Arizona Department of Transportation

MEMORANDUM

To: All Users of the Construction Standard Drawings- C-Standards	**Date:** July 19, 2001
From: John L. Louis Assistant State Engineer Roadway Engineering Group	**Subject:** C-Standards Revisions

DESIGN APPROVED John L. Lewis	STATE OF ARIZONA DEPARTMENT OF TRANSPORTATION DIVISION OF HIGHWAYS STANDARD DRAWINGS	REV. 7/01
APPROVED FOR DISTRIBUTION Ronald C. Williams	DRIVEWAY & TURNOUT LAYOUTS	DRAWING NO. C-06.10 Sheet 1 of 2

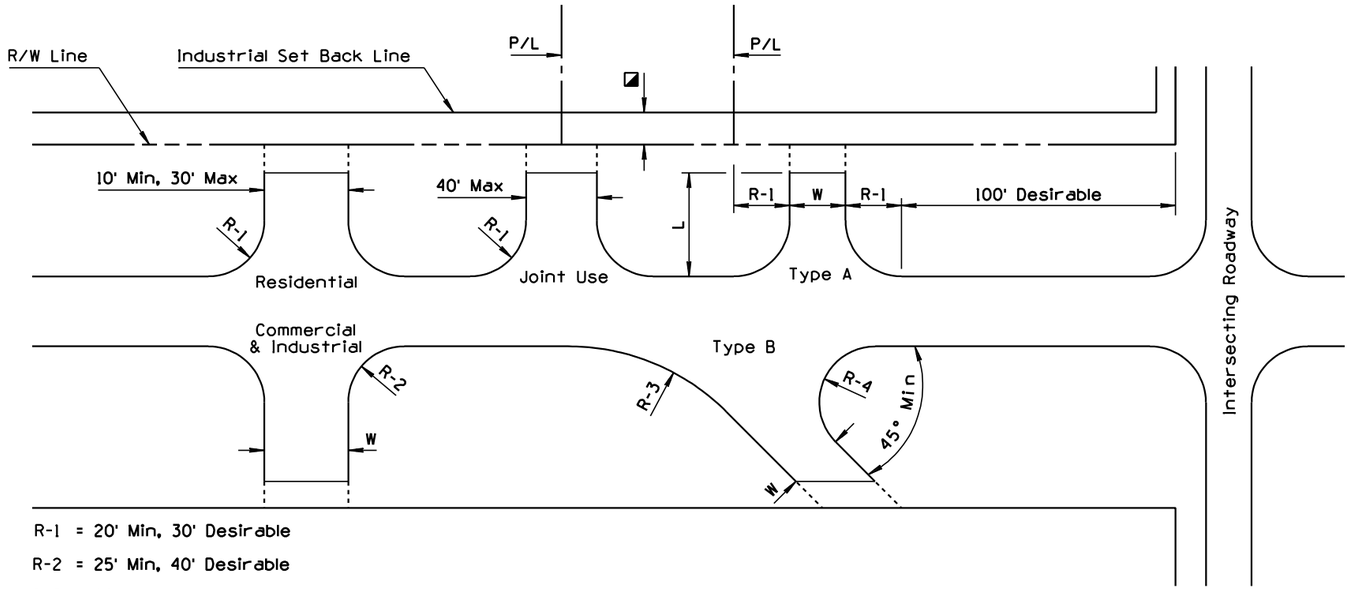
6.10 - eliminate old Type B turnout

NO	DESCRIPTION OF REVISIONS	MADE BY	DATE
1	ADDED NOTE	JNP	8/99
2	REVISED NOTE & REMOVED PREVIOUS TYPE B TURNOUT	RLF	7/01
3			
4

ELEVATION
BARRIER WITH CURB AND GUTTER

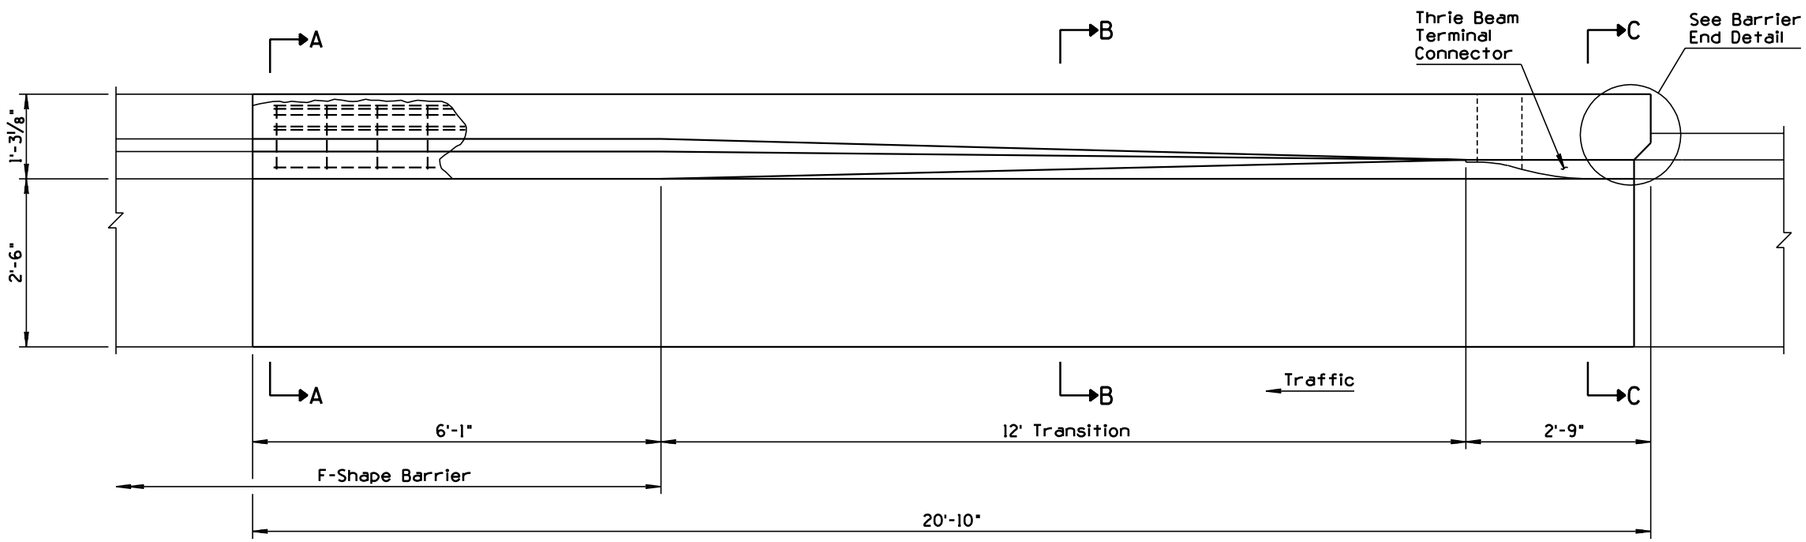
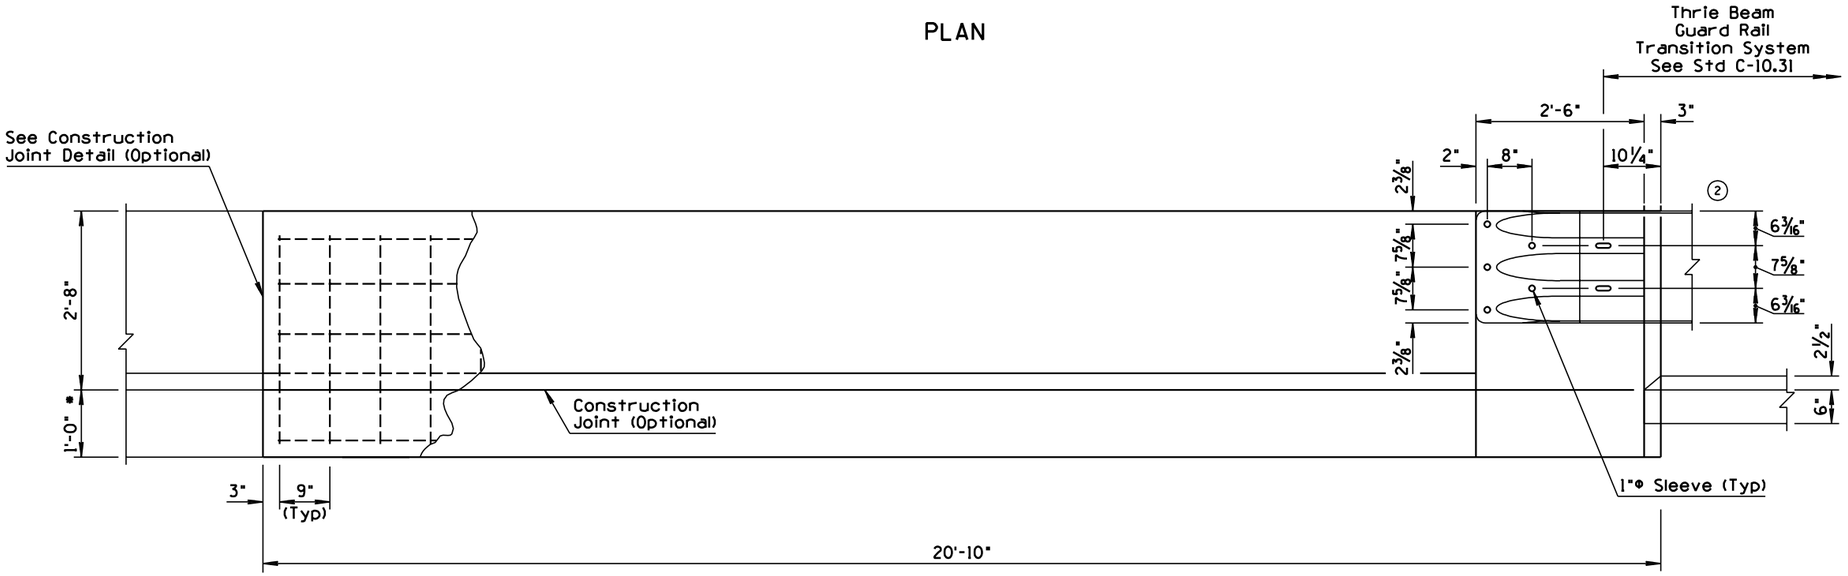
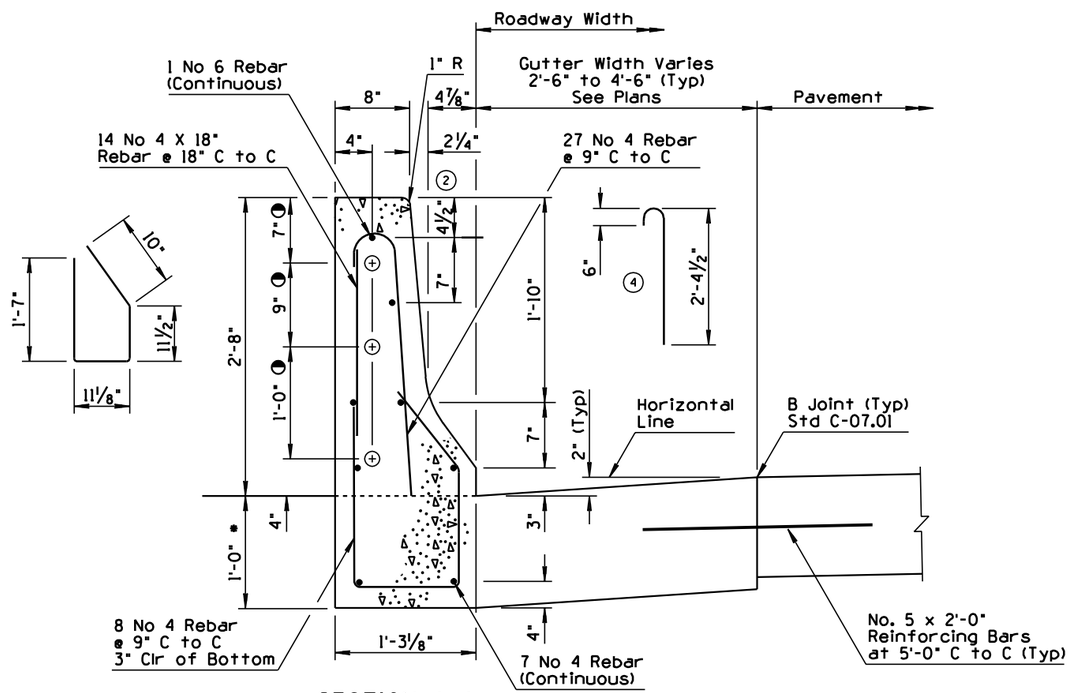
NO	DESCRIPTION OF REVISIONS	MADE BY	DATE
1	REVISED TO MEET NCHRP 350 REQUIREMENTS	JNP	8/99
2	RAISED THRIE BEAM 1"	RLF	7/01
3			
4

NO	DESCRIPTION OF REVISIONS	MADE BY	DATE
1	REVISED DRAWING & DIMENSIONS	JNP	4/00
2	RAISED THRIE BEAM 1" & REPOSITIONED TOP REBAR	RLF	7/01
3	REVISED FROM PIPE TO SLEEVE	RLF	7/01
4	REVISED REBAR DIMENSIONS	RLF	7/01

2. Guard rail height to top of rail has been revised from 27" to 28". This necessitates a corresponding 1" increase in the height of the thrie beam transition to concrete barrier.

BARRIER WITH CURB AND GUTTER

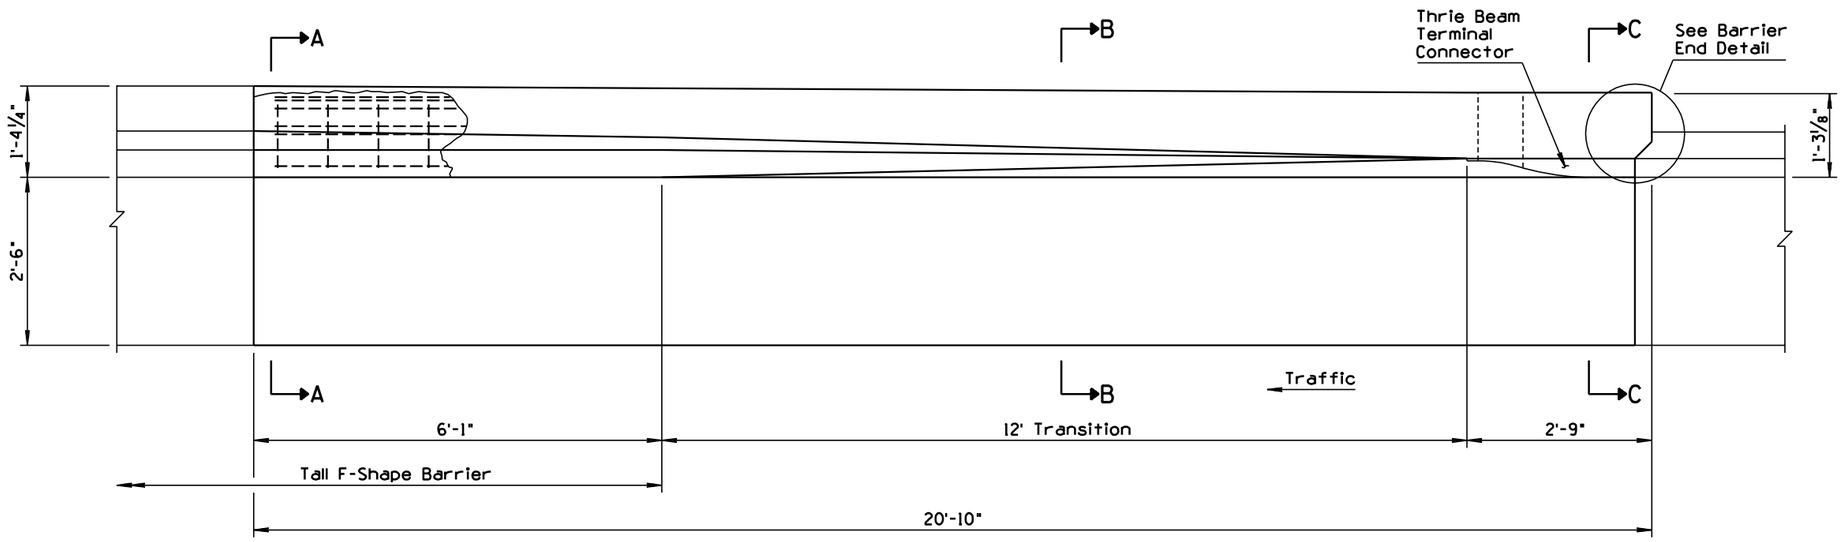
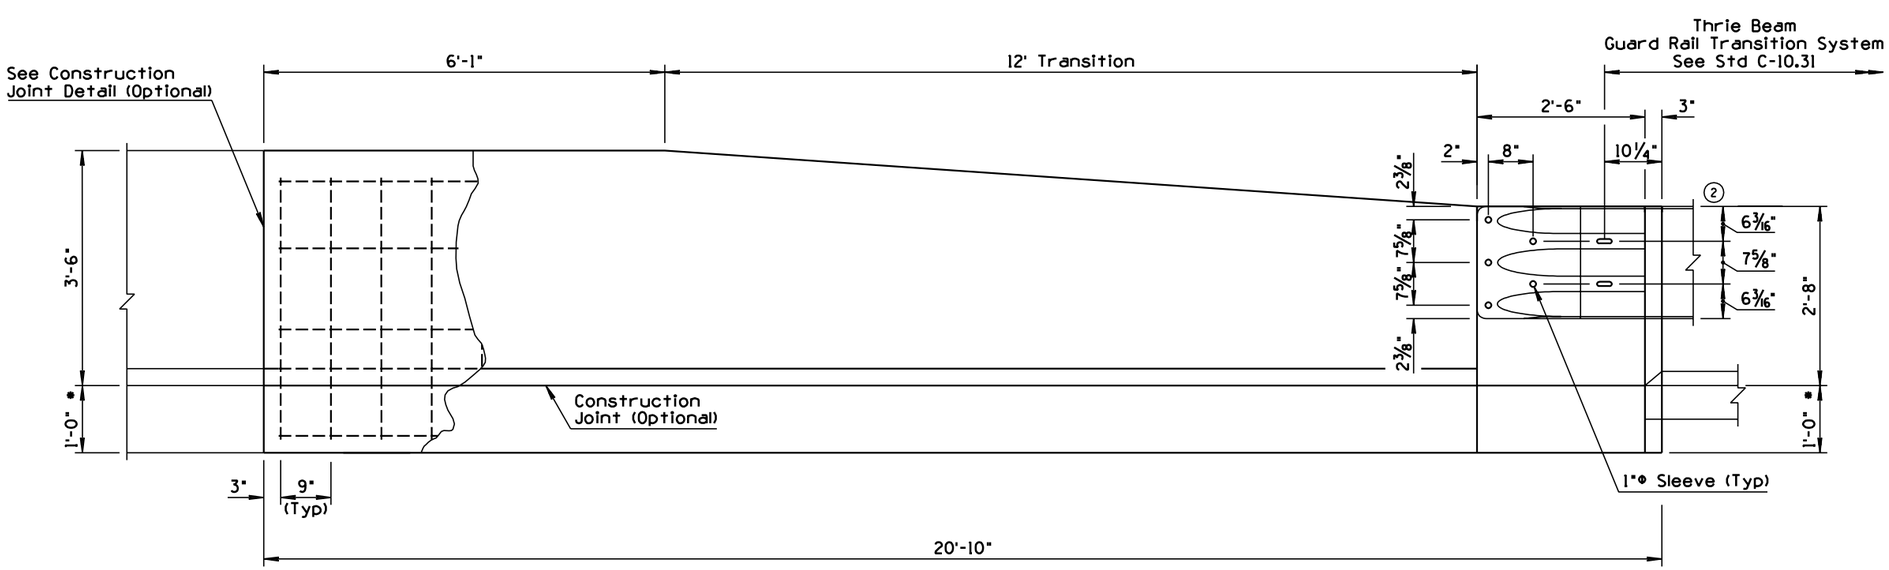
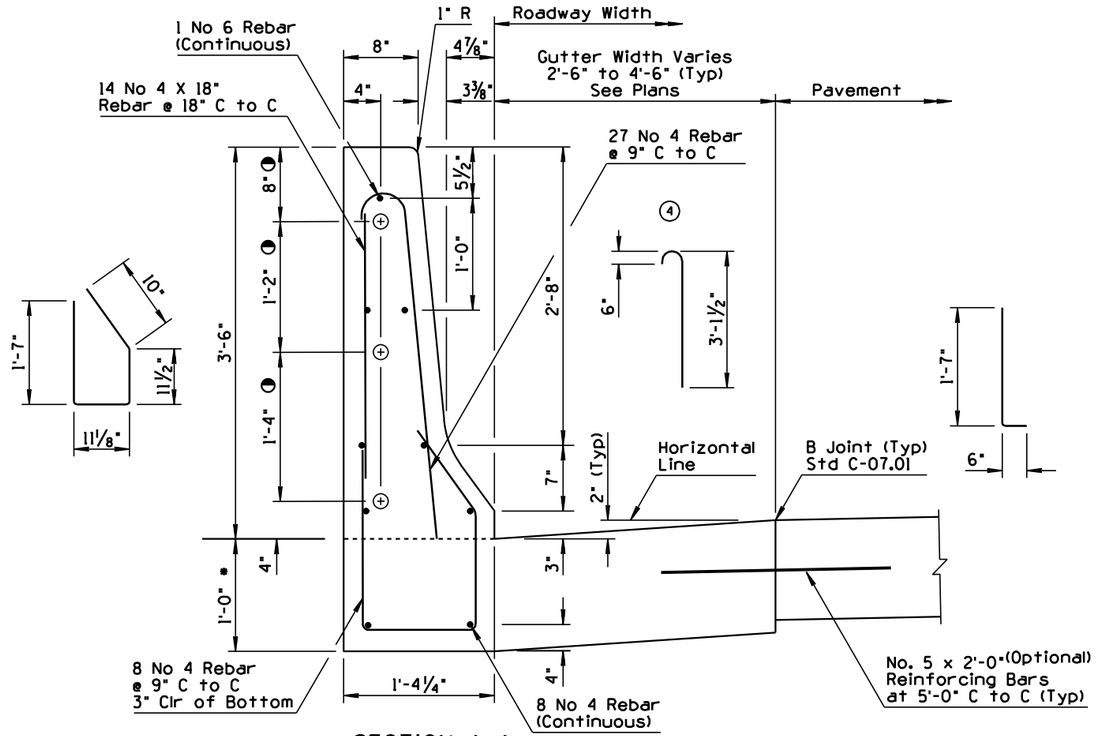
NO	DESCRIPTION OF REVISIONS	MADE BY	DATE
1	NEW STANDARD DEVELOPED	JNP	8/99
2	RAISED THRIE BEAM 1"	RLF	7/01
3			
4

NO	DESCRIPTION OF REVISIONS	MADE BY	DATE
1	REVISED DRAWING & DIMENSIONS	JNP	4/00
2	RAISED THRIE BEAM 1" & RAISED TOP REBAR	RLF	7/01
3	REVISED FROM PIPE TO SLEEVE	RLF	7/01
4	REVISED REBAR DIMENSIONS	RLF	7/01
